Published date	13/02/2019
Document number	SUPAIR_2019/02/001
Page number	1 / 2

Safety info

SUBJECT : Front reserve container standard

FRONT RESERVE CONTAINER STANDARD

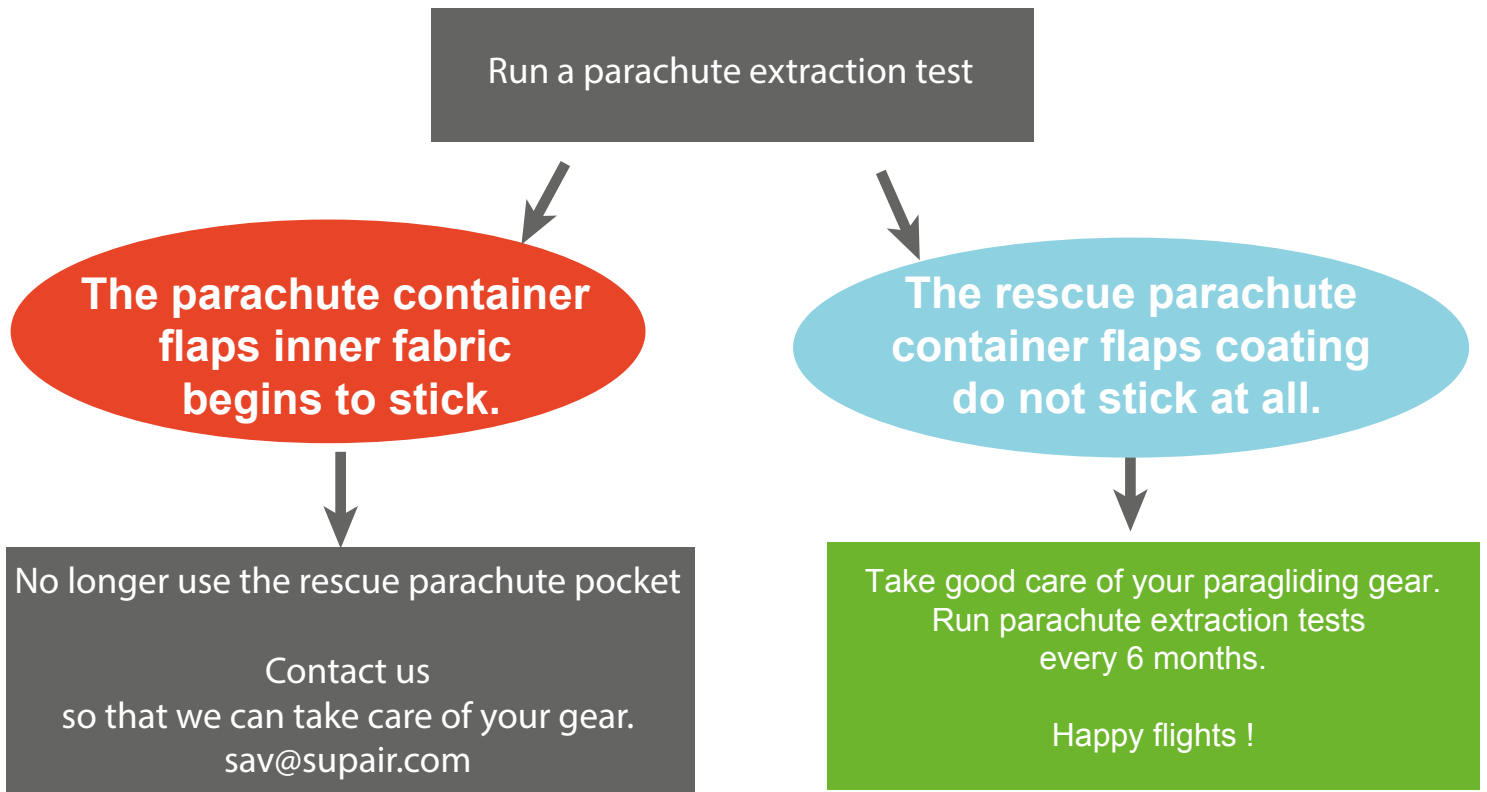
The coating on the rescue parachute container flaps might become sticky.

The coating of the black Cordura might deteriorate overtime and become sticky. It is possible that the degraded rescue parachute container flaps affect the parachute extraction, making it harder or even impossible.

During their yearly parachute extraction test, several pilots noticed that the rescue parachute container flaps had become sticky.

(Fabric defect as regards to the stability of the coating overtime)

DELAIS : **The inspection must be done immediately**
